9 December 2024

**SUBMISSION from 220 and 220A Fitzgerald Avenue, Maroubra
Proposed development at 195-213 Fitzgerald Avenue and 40-64 Yorktown
Parade, Maroubra - State Significant Development Application (SSD-71454960)**

Figure 2 – the semi-detached dwellings at 220 and 220A Fitzgerald Avenue

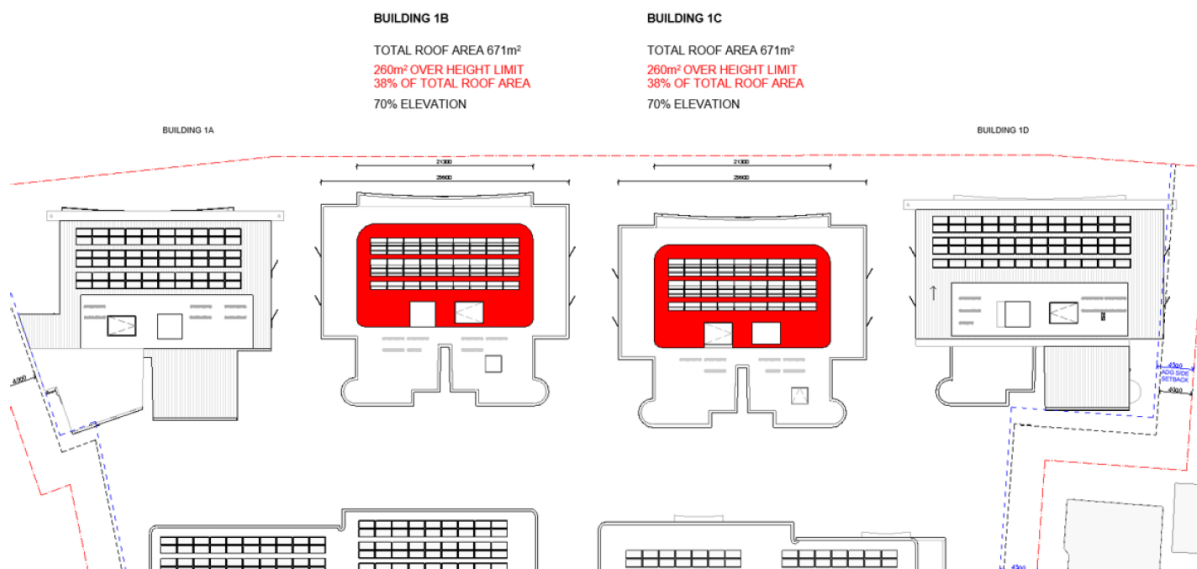
My clients' property at 220 and 220A Fitzgerald Avenue, Maroubra is directly opposite, to the north of the proposal. It accommodates two, semi detached dwellings, car parking and associated structures within a landscaped setting [figure 1]. The property is zoned R2 low density residential under Randwick LEP 2012 [LEP] and has an 18.5m [approximate] frontage to Fitzgerald Avenue.

Figure 7 - Existing view from 220/220A Fitzgerald Avenue [source: C Blackstone]

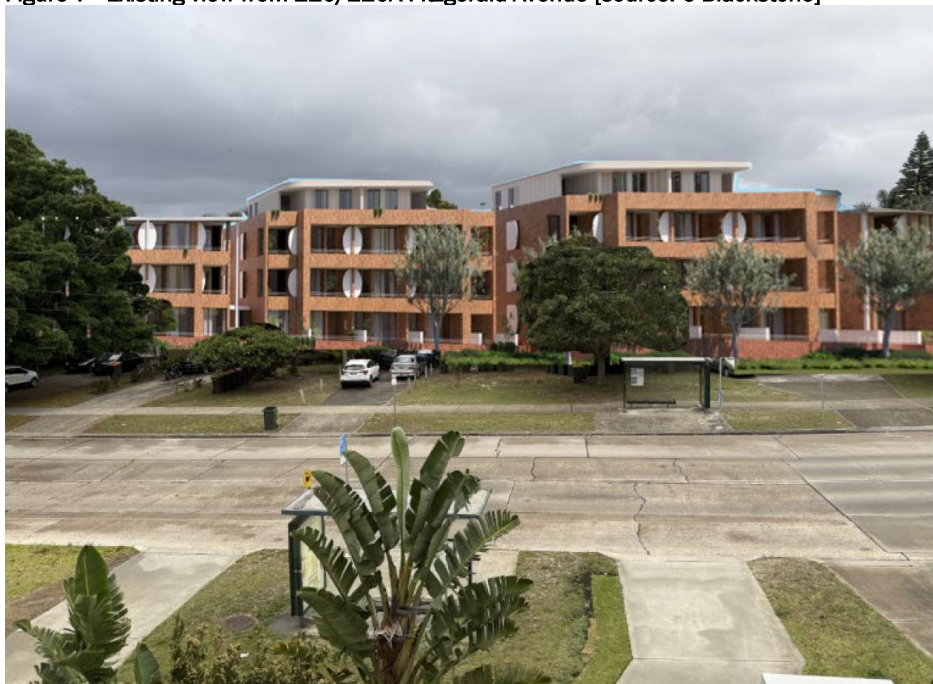
The raised undulating topography to the north [where my client's properties are located] results in tiered housing, that is elevated above the site. The proposed 4-storey character will be visible from the streetscape and nearby development [figures 7 and 8 below].

The size and scale of the proposed development is out of character for the area. It will result in an adverse impact on the Fitzgerald Avenue streetscape, and incompatibility with the predominant 2-storey development character [figures 7 and 8 below].
